Subject:	Town of Cumberland Town Office Parking Expansion -Major Site Plan Review
From:	Carla Nixon, Town Planner
To:	Town of Cumberland Planning Board
Date:	April 16, 2020

Subject:Town Office Parking ExpansionTown of Cumberland Site Plan Review ApplicationResponse to Peer Review Comments dated 4/13/2020

CTB: SME-STD

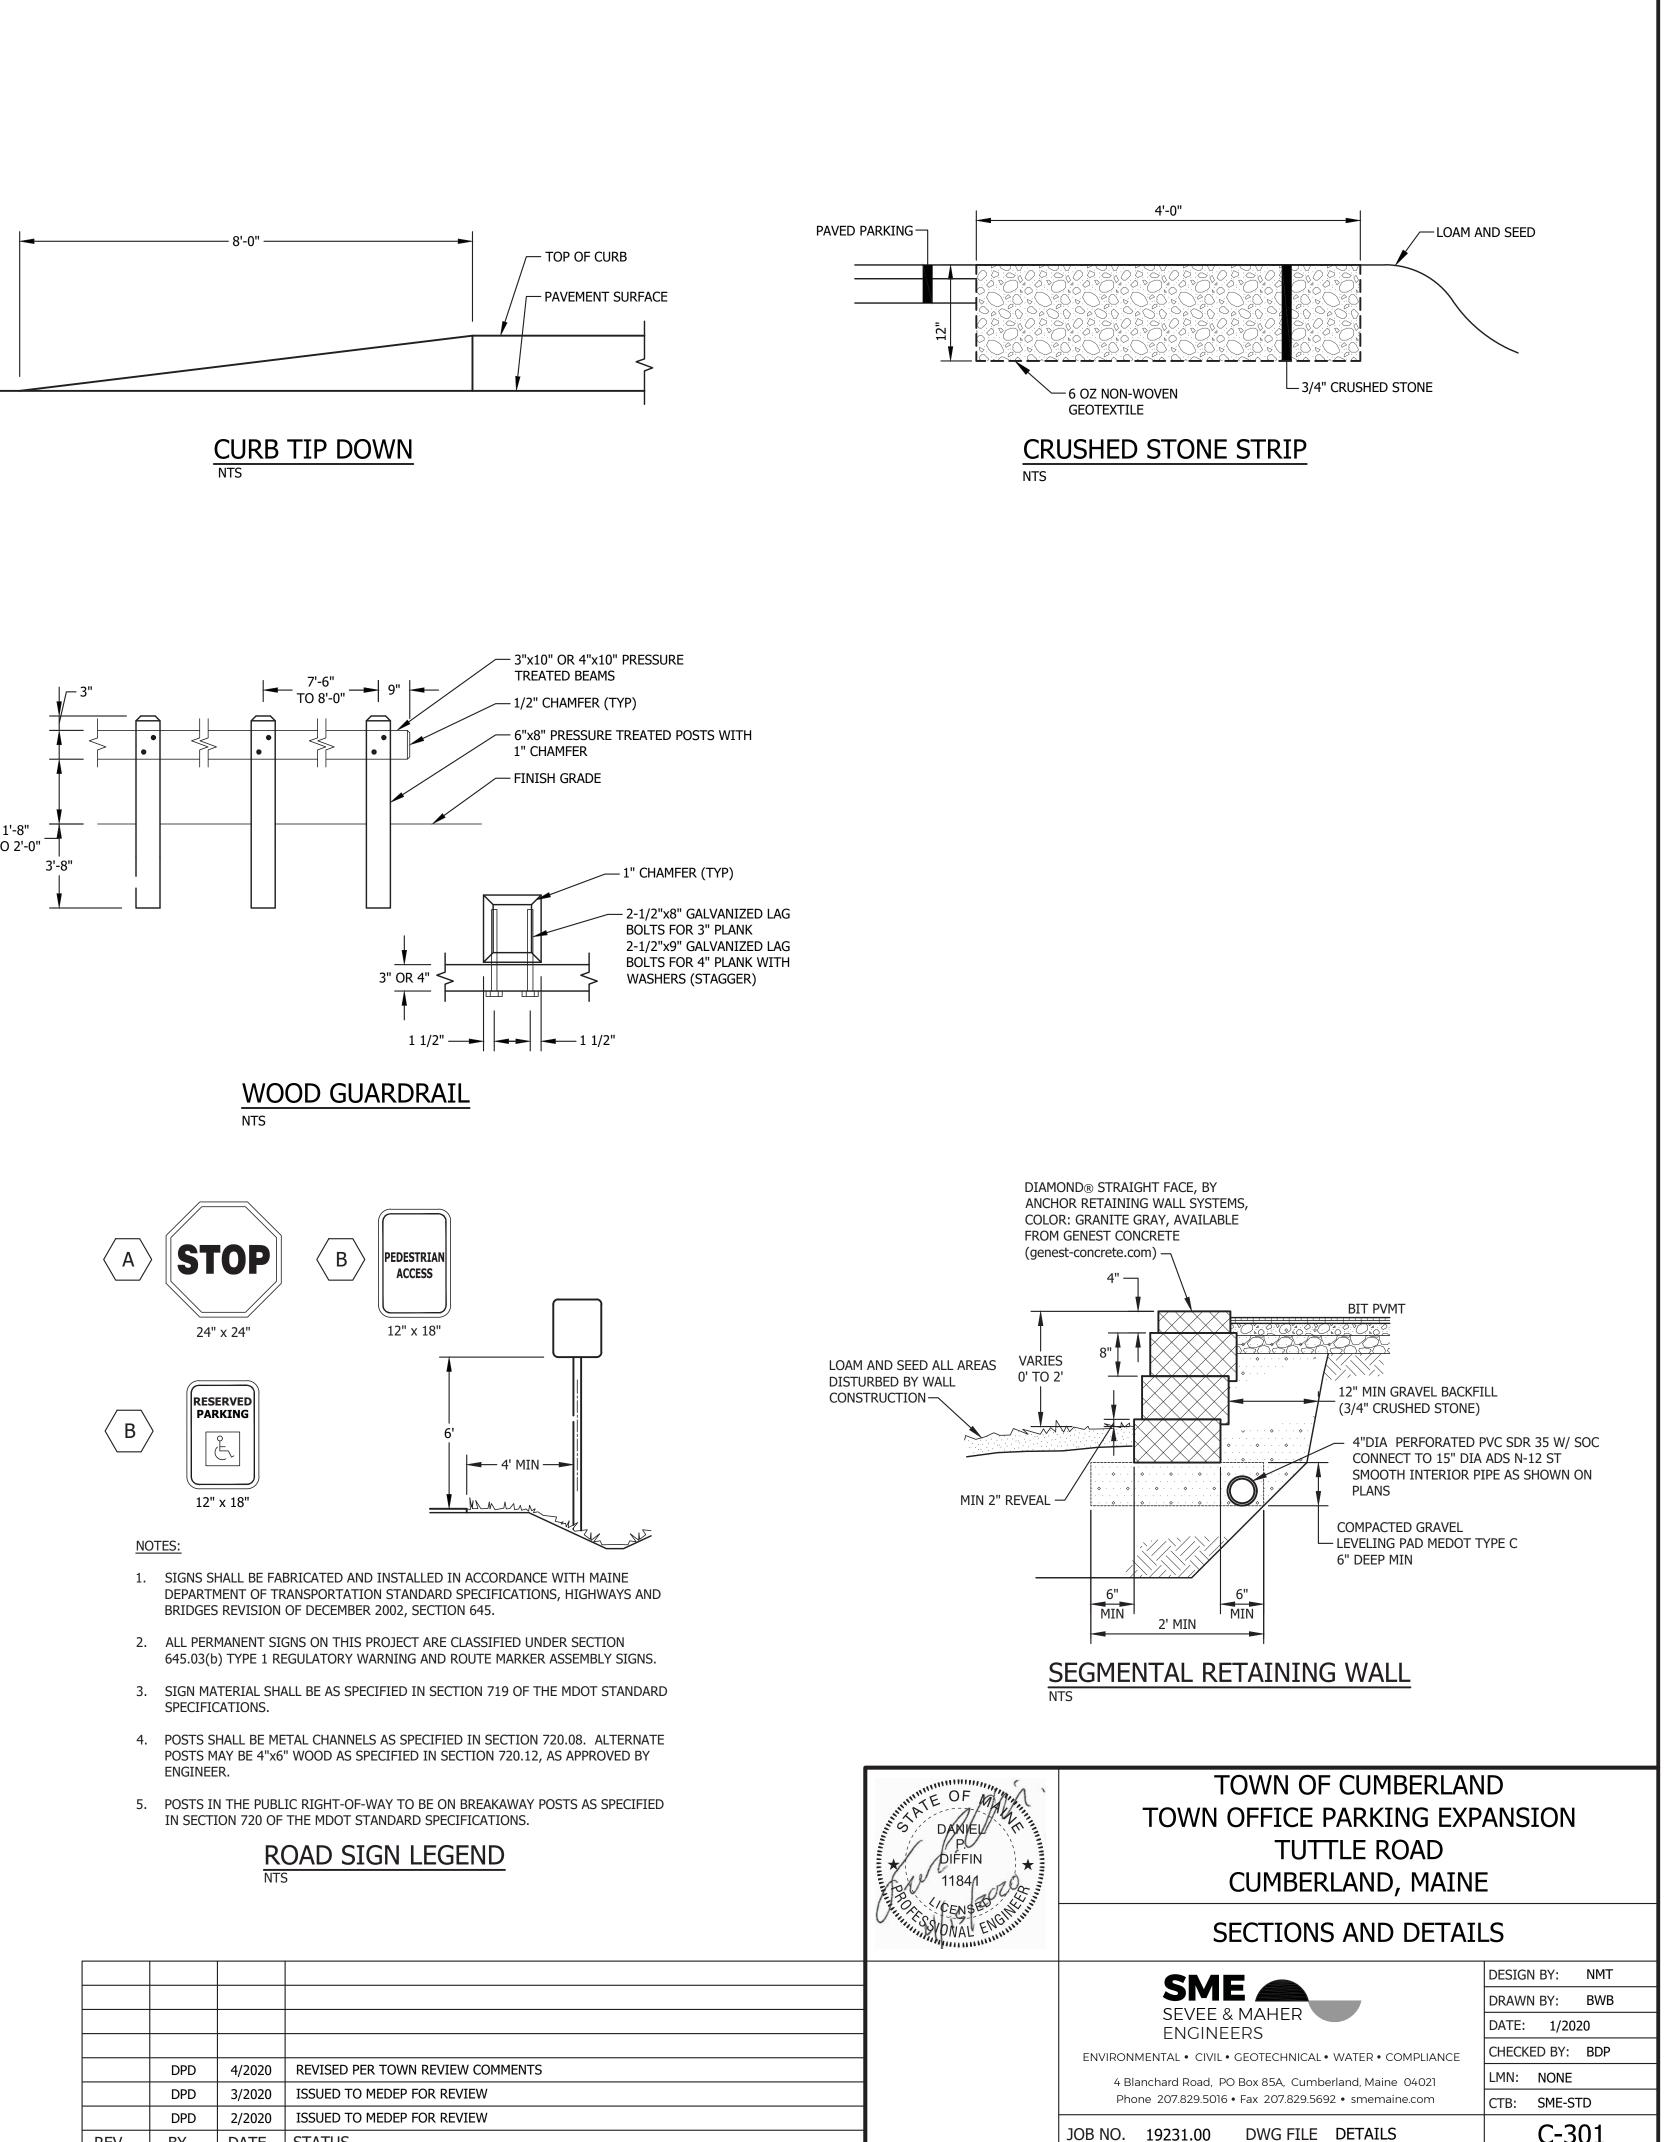
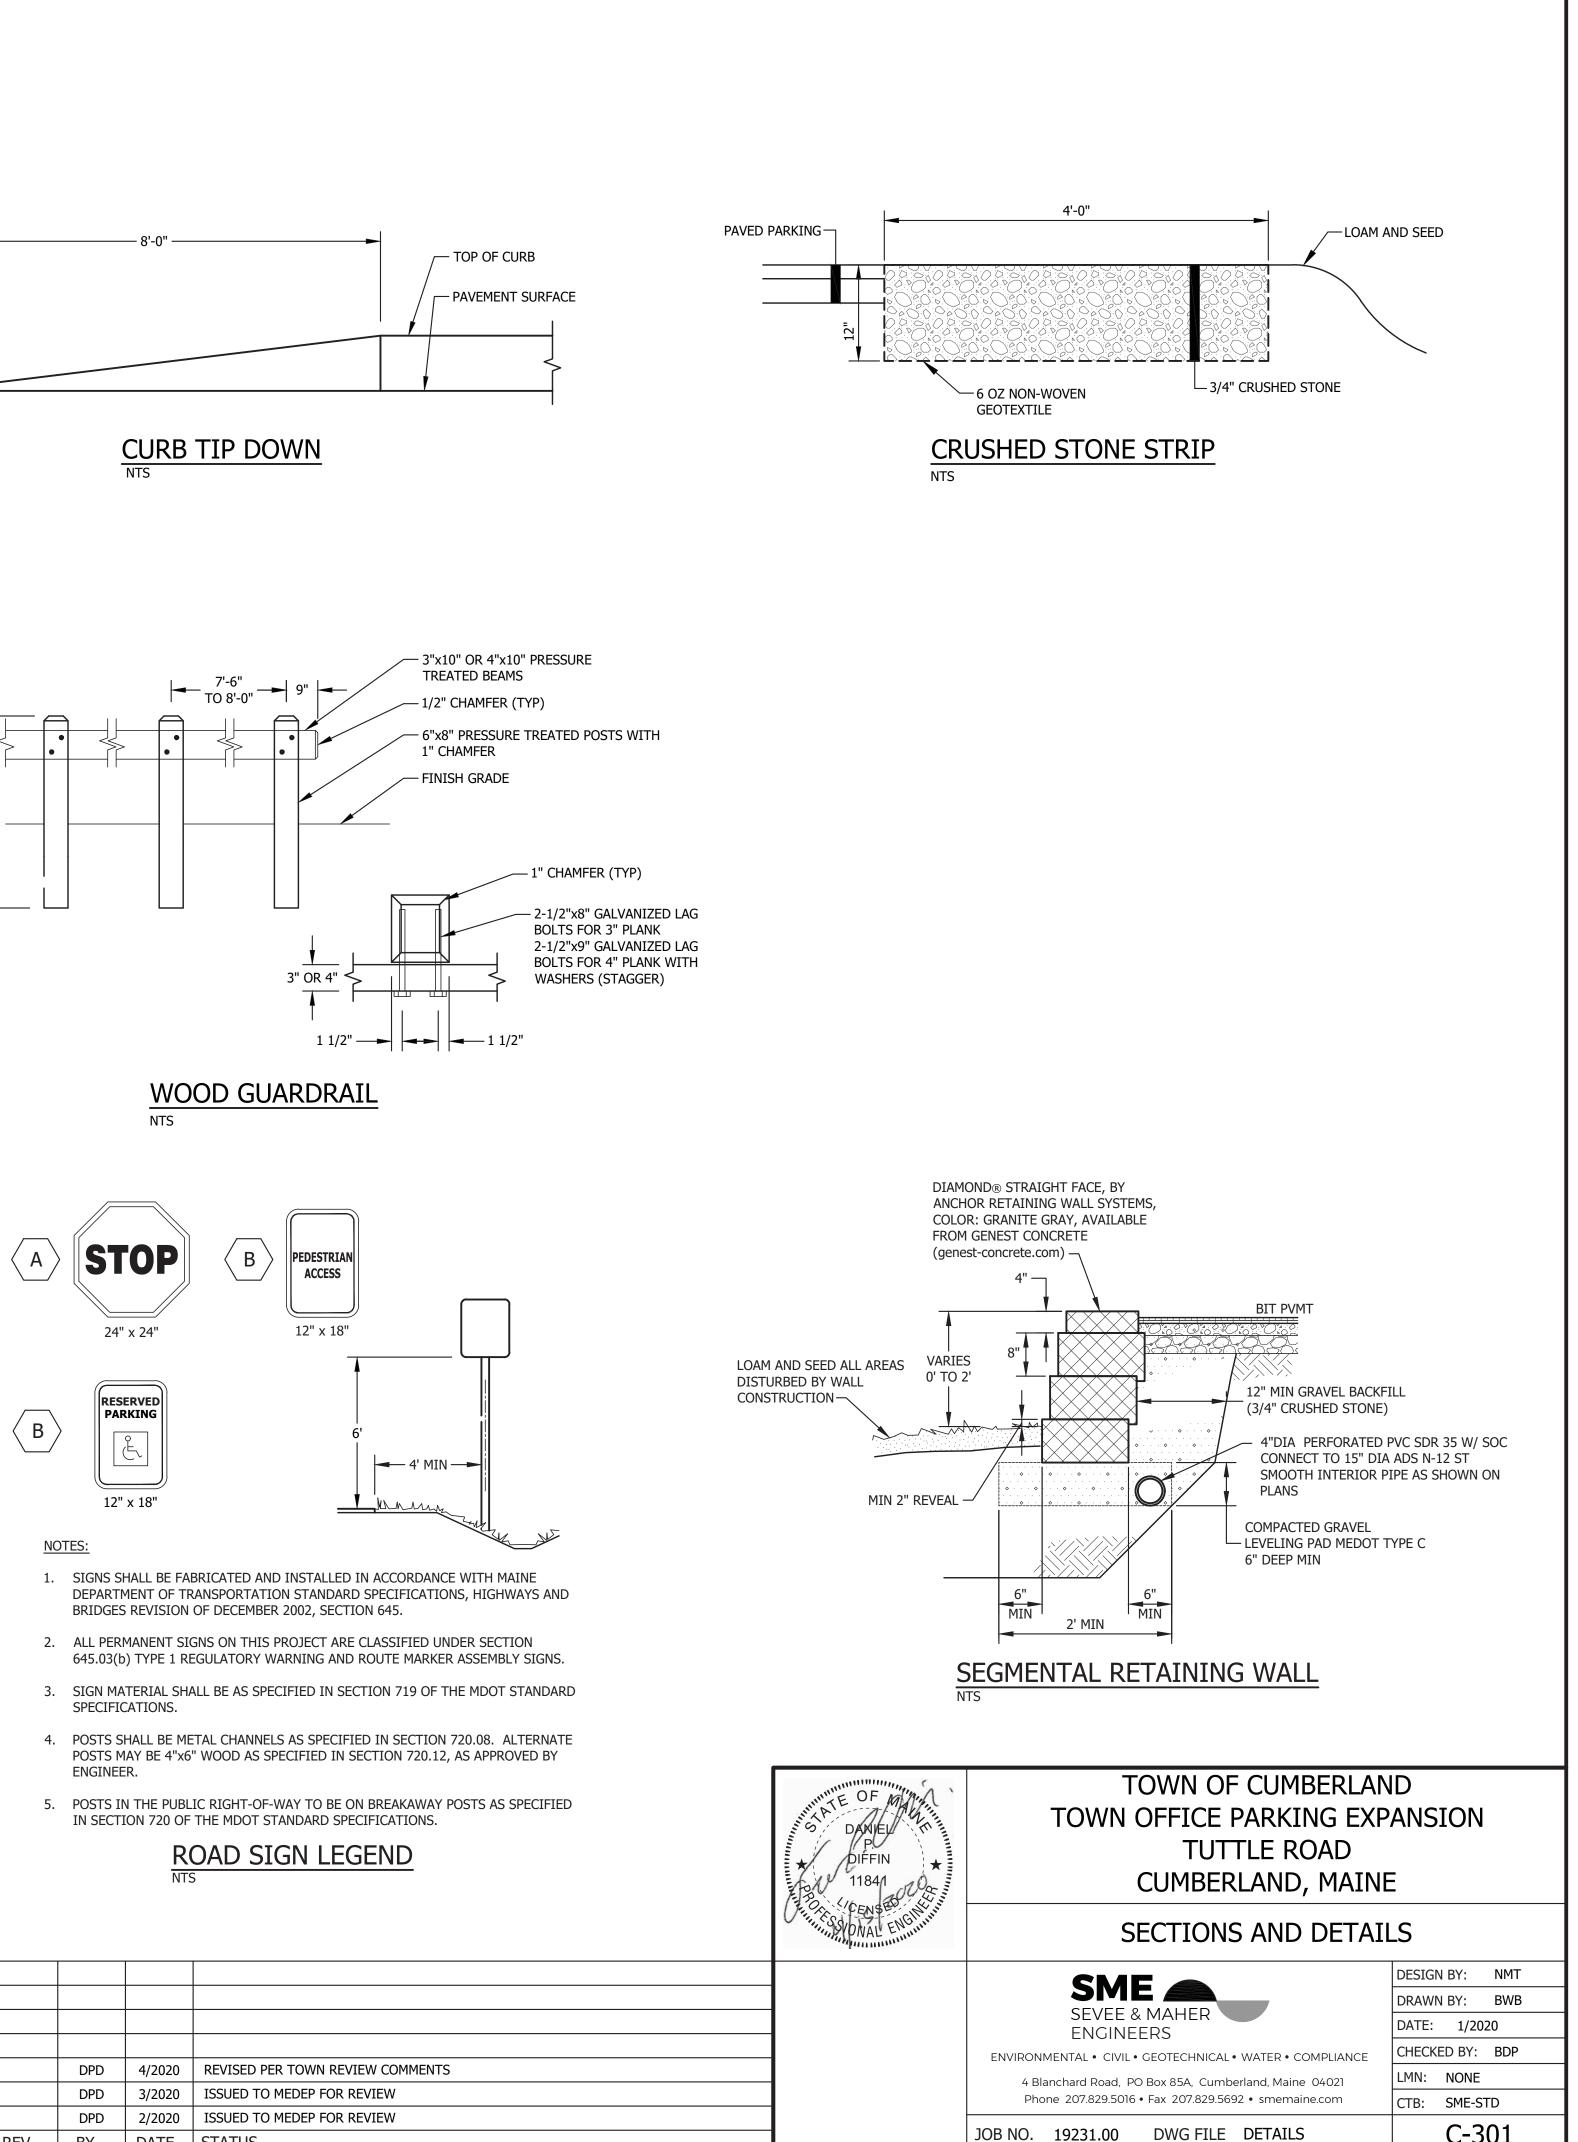
- With respect to the Stormwater Analysis and Plans, we offer the following comments:
 - Provide temporary seeding mix on plan sheet C300
 - Correct typo in Section 6.C Mulch on plan sheet C300

- With respect to the Stormwater Analysis, we offer the following comments:
 - Provide temporary seeding mix on plan sheet C300

Correct typo in Section 6.C Mulch on plan sheet C300

<u>SME Response</u>: A mix for temporary seeding was added to Drawing C-300 in accordance with the Maine Erosion and Sediment Control Practices Field Guide for Contractors.

<u>SME Response:</u> Typo on Drawing C-300 has been corrected.
